**KZRV, LP**  
**Repair Instructions**

**Coupler Recall**  
**NHTSA #22V-161**  
**Transport Canada #2022-120**  
**KZ # KZ-2022-01**

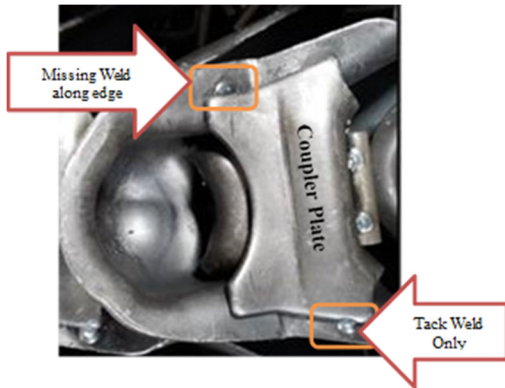
1. Inspection location: Bottom side of coupler located at the front end of the a-frame.

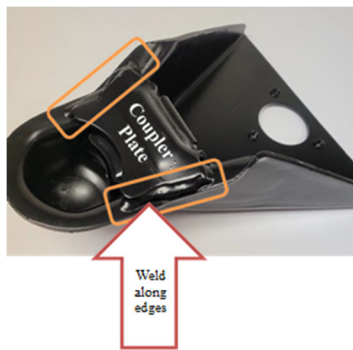
2. Underneath the coupler, use a flashlight to inspect the welds at each side of the bottom coupler plate.
  - a. To Pass Inspection: A weld bead should run along each side of the plate.

To Fail Inspection: A weld bead will not run along the side of the plate and there will only be tack welds

### **STEP 2: REPAIR IF VISUAL INSPECTION FAILS**

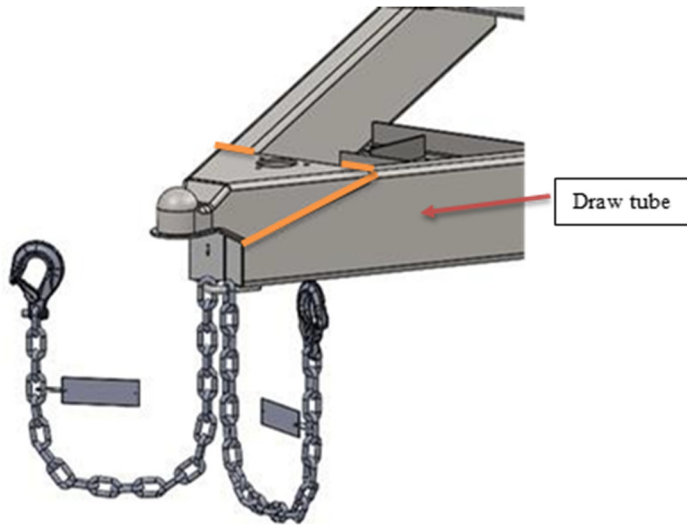
1. In a circumstance that the coupler is only tack welded on the underneath plate, the coupler will need to be replaced by a qualified welder.
2. Safely support the front of the RV with jack stands and remove the tongue jack.
3. Carefully cut through the perimeter welds of the coupler allowing the defective coupler to be removed. *Use caution not to damage the draw tubes when cutting through the welds.*

4. Using a grinder, remove any excess weld from the draw tubes once the coupler has been removed
5. Prep the replacement coupler by removing the paint from the weld locations.
6. Weld the replacement coupler in place just as the original was welded.
7. Paint raw steel areas.
